Memorandum

Date: September 19, 2019

Project: SSP-1453, Task 39

Subject: **Comments on 2004 Groundwater Modeling Report Prepared by Conestoga-Rovers & Associates (CRA)**

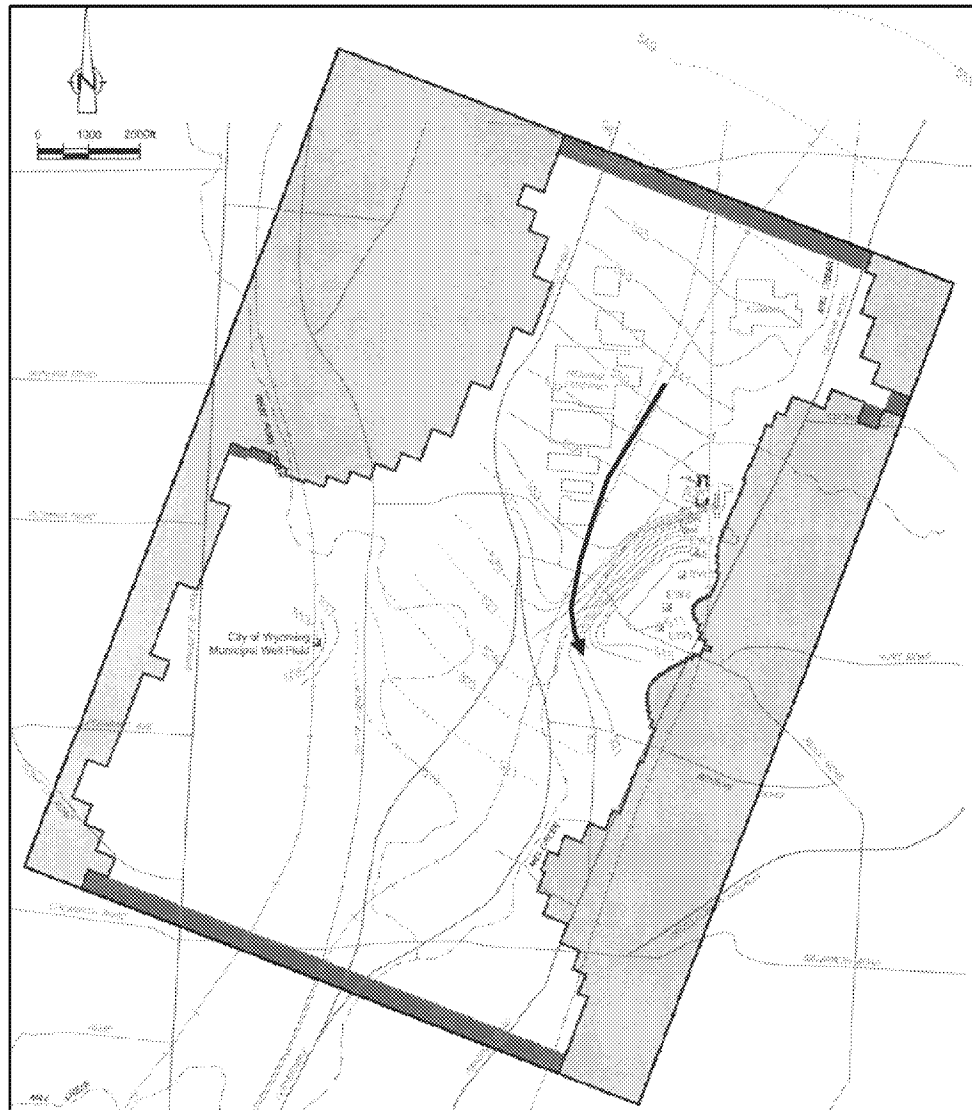
1. No regional-scale data were incorporated to constrain the elevation of the top of the LA. The elevations of the top of LA throughout the Site were interpreted using kriging and are shown in Figure 5.5 (reproduced below). Bulls-eye shapes in the contours can be observed which may be largely due to the distribution of data and strong contrasts in the elevations at neighboring locations. The data are sparse in the southern part of the model domain, particularly along the eastern and western sides of Mill Creek Valley. In contrast to other model surfaces (bedrock), no previous interpretations were incorporated to constrain the elevation of the top of the LA.

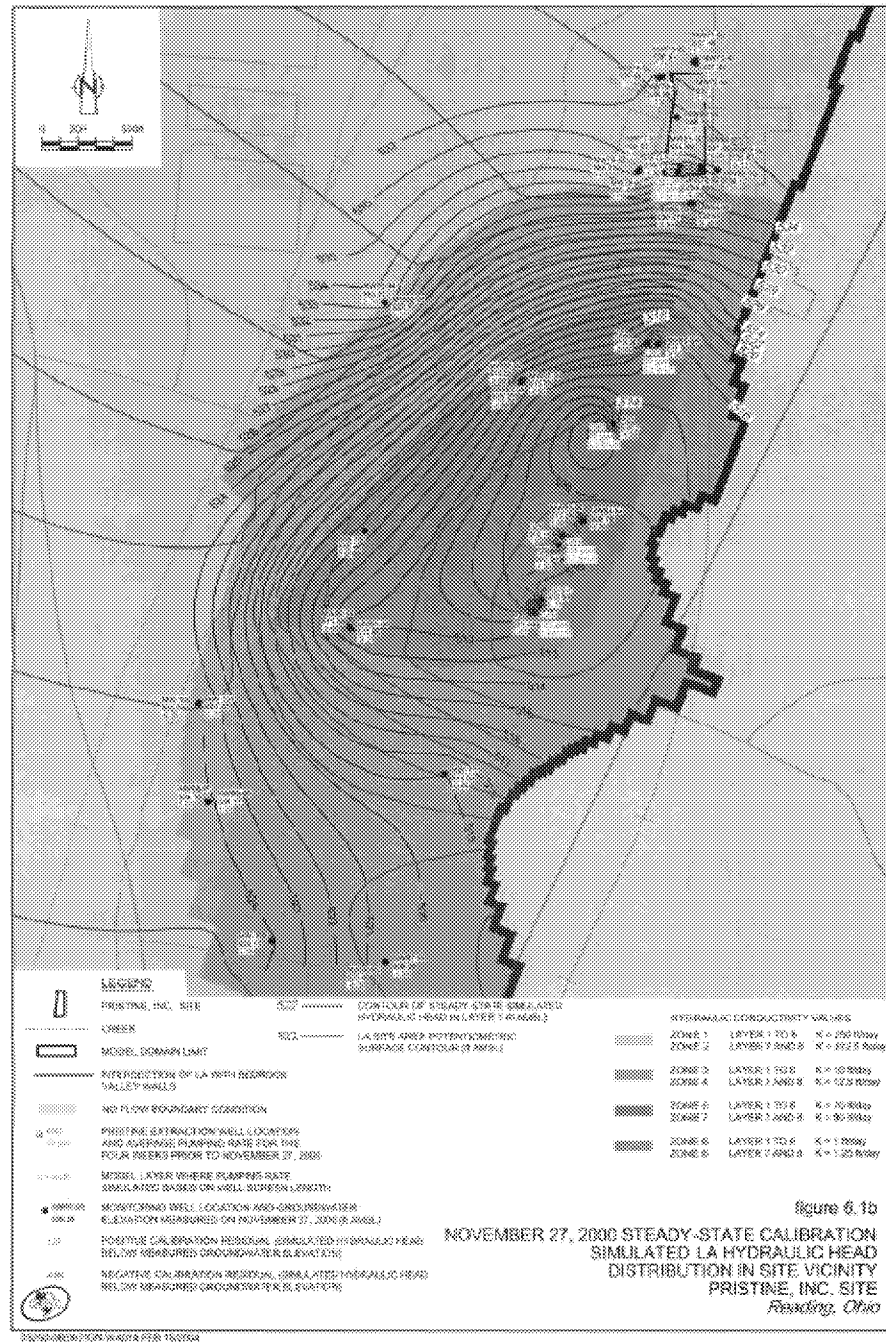
2. Mill Creek and the West Fork Creek are not represented in the 2004 model because they are assumed to impact the unconfined aquifer above the LA and not the LA directly (see General Comment #1). Mill Creek and the West Fork Creek should be simulated explicitly in the model, using the MODFLOW River or Drain packages for example, when the model is expanded to include the upper unconfined aquifer in the area of the Site. The potentiometric surface contours of November 2000 shown in Figure 3.1 by Schalk and

Schumann (2002)⁴ show evidence of water discharging to the Mill Creek following the red line in the figure below⁵.

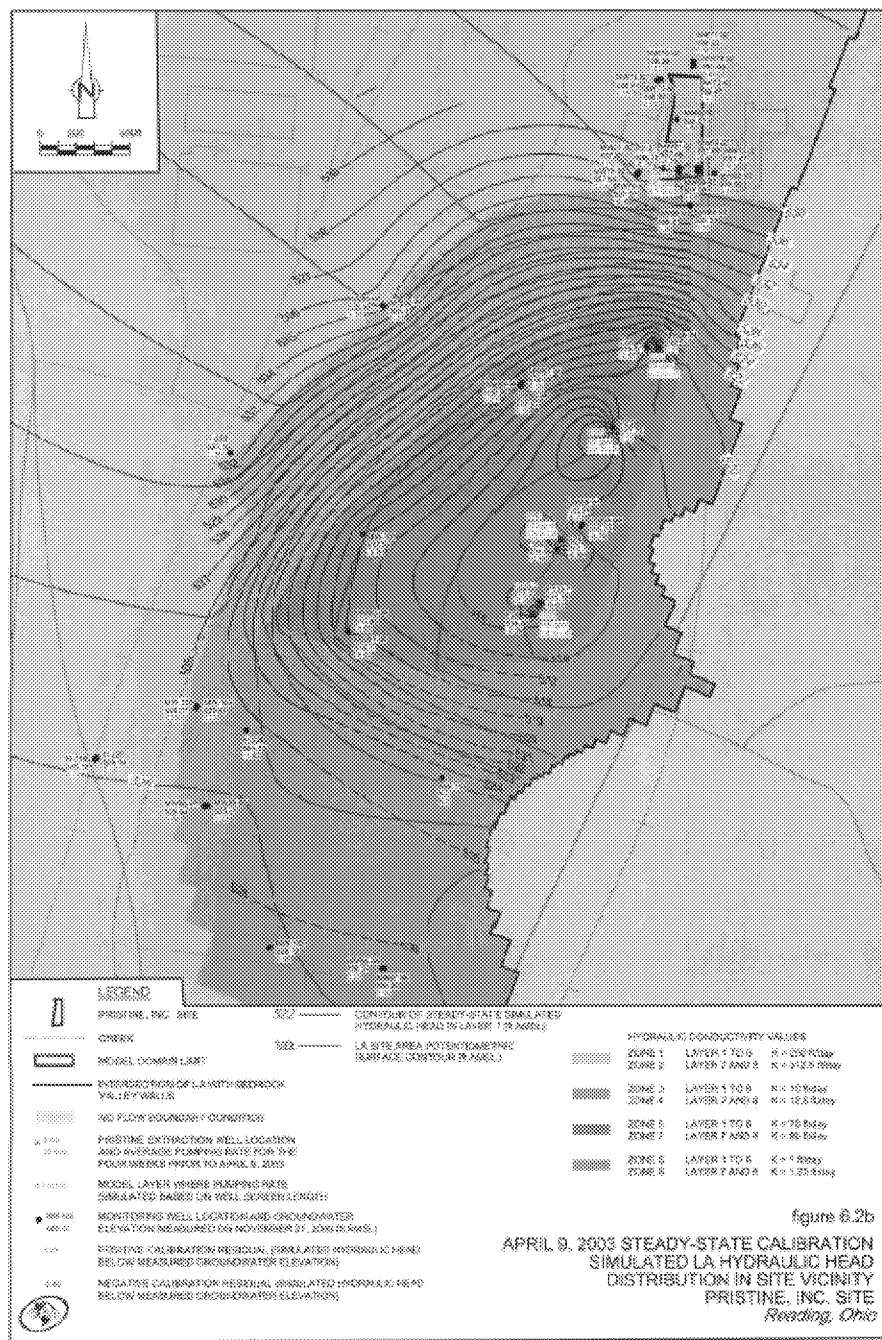
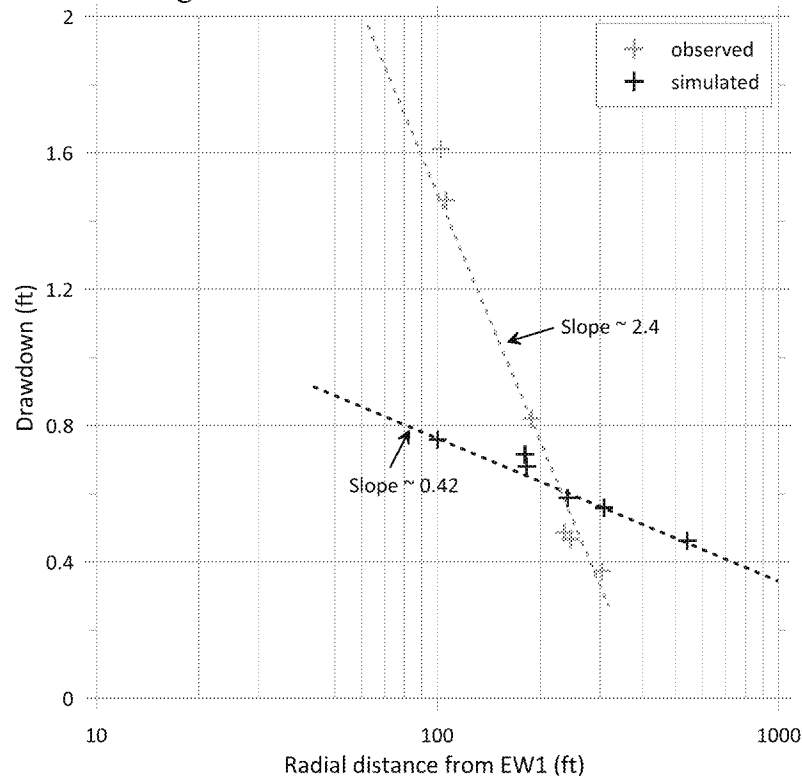
- e. The simulated water level contours from the steady-state simulation for November 27, 2000 are generally 1 ft lower than the interpreted LA potentiometric surface contours for that date [USGS WRIR 02-4167, Schalk and Schumann (2002)]. In addition, the cones of depression for the pumping wells EW3, EW4 and EW5 are very different from the interpreted water levels (Figure 6.1b: black contours denote interpreted groundwater levels, blue contours denote simulated groundwater levels). The 2004 model over-predicts the groundwater elevations around the well field in areas represented by hydraulic conductivity zones 5 & 7. In addition, the simulated hydraulic gradient is smaller than the observed by a factor of 2 to 3. These factors suggest that the hydraulic conductivity values assigned in zones 5 and 7 might be too large. A similar pattern can be observed in the water levels for the April 9, 2003 steady-state simulation (Figure 6.2b): simulated hydraulic gradients again appear smaller than the observed by a factor of about 2 to 3.

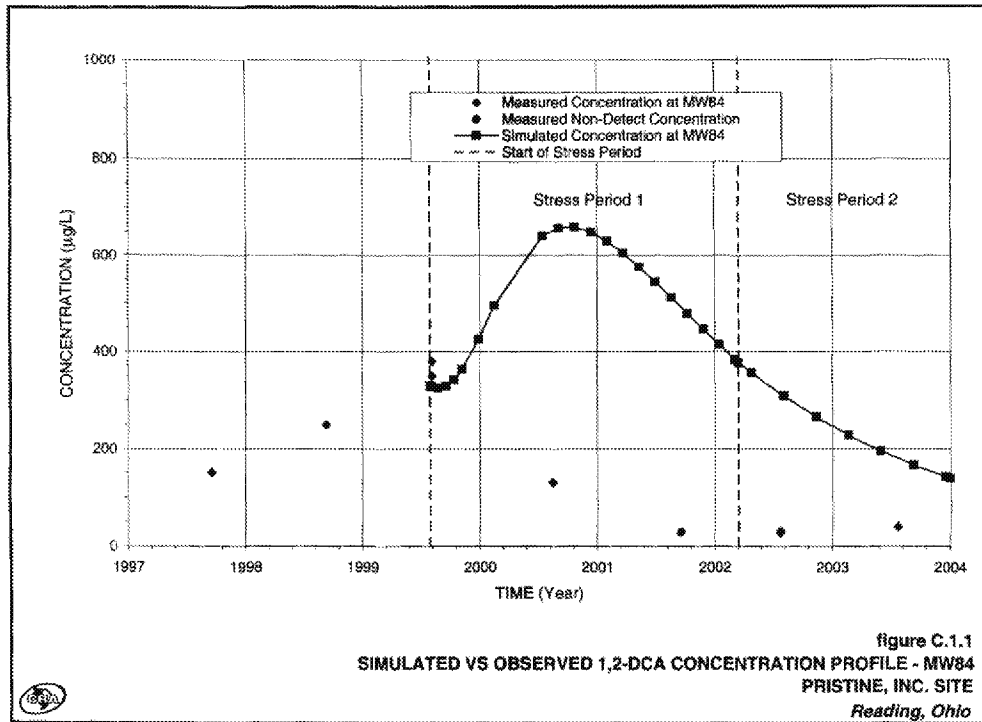
- g. At MW94, close to pumping well EW4 (within hydraulic conductivity zones 5 & 7), the transport model over-predicts concentrations, implying that the plume has not

been captured by the pumping well as soon as expected. This may be another line of evidence that the transmissivity around the well fields is too large.

Original model,
 $\alpha_L = 42$ ft

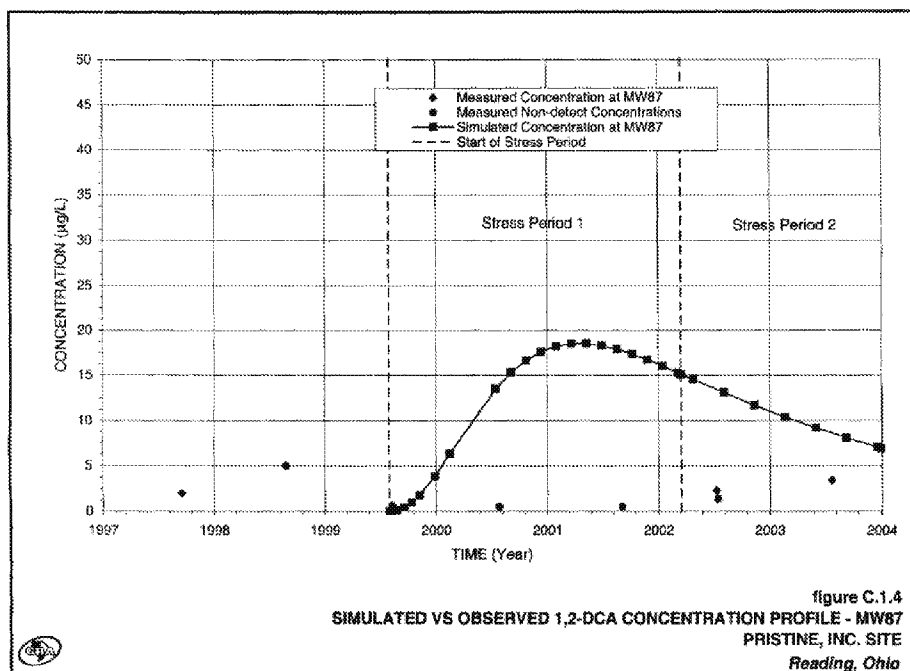
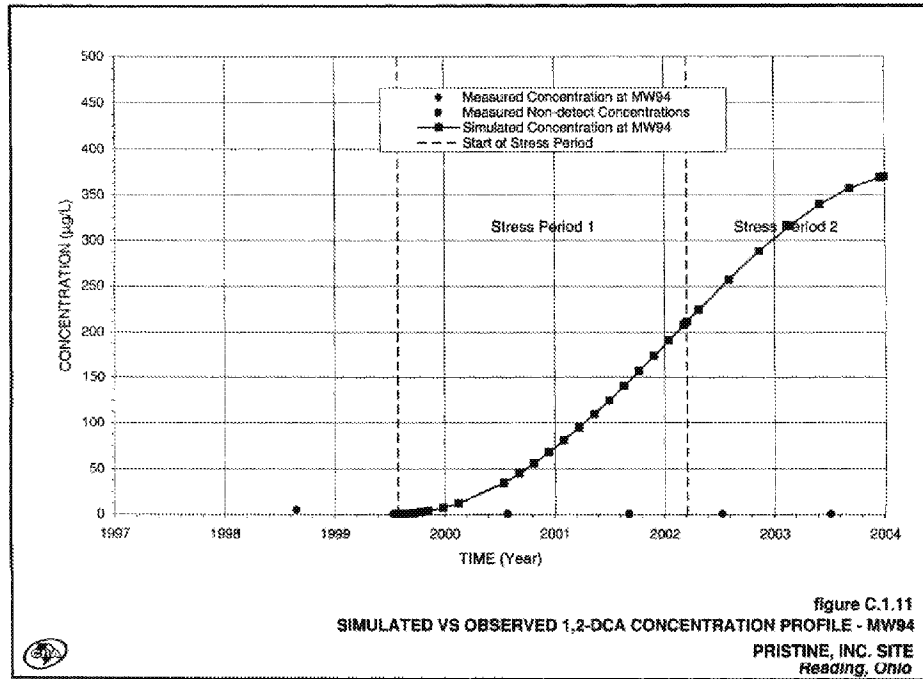
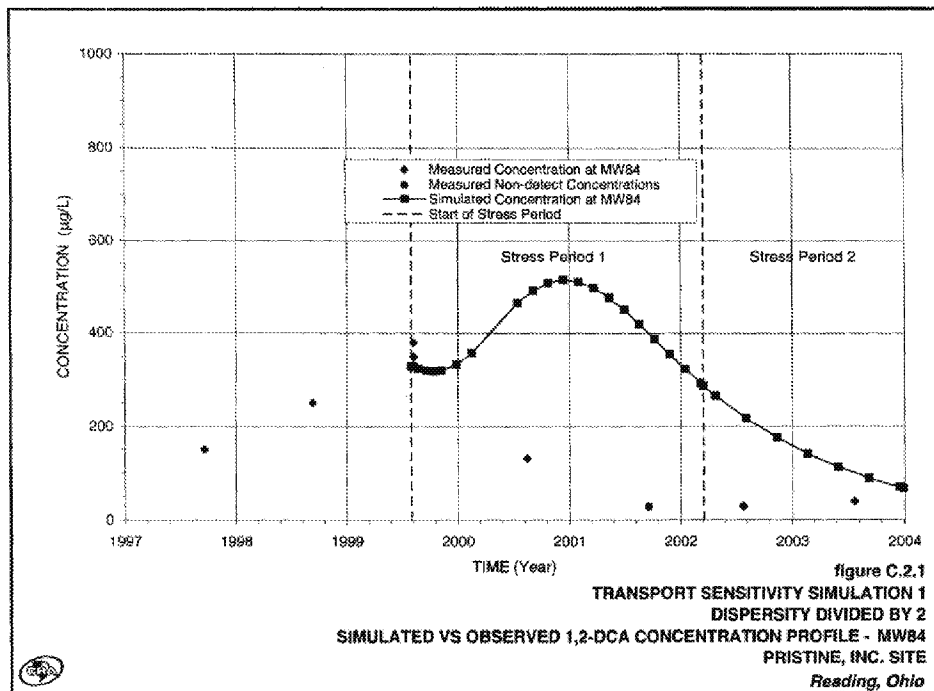
- b. The mismatch of transport simulation results to observations is particularly evident at locations outside the plume center such as MW84, MW87 and MW94. Sensitivity analyses were conducted on two parameters, longitudinal dispersivity and sorption coefficient. The results show that reducing the longitudinal dispersivity, α_L , to half (i.e., 21ft) improves the match considerably at wells where the initial match is relatively poor. Comparisons of the match between the initial transport simulation and the sensitivity analysis #1 at three monitoring locations, MW84, MW87 and MW94 are shown below. The trends are similar, but the simulated magnitudes of the concentrations are closer to those observed.
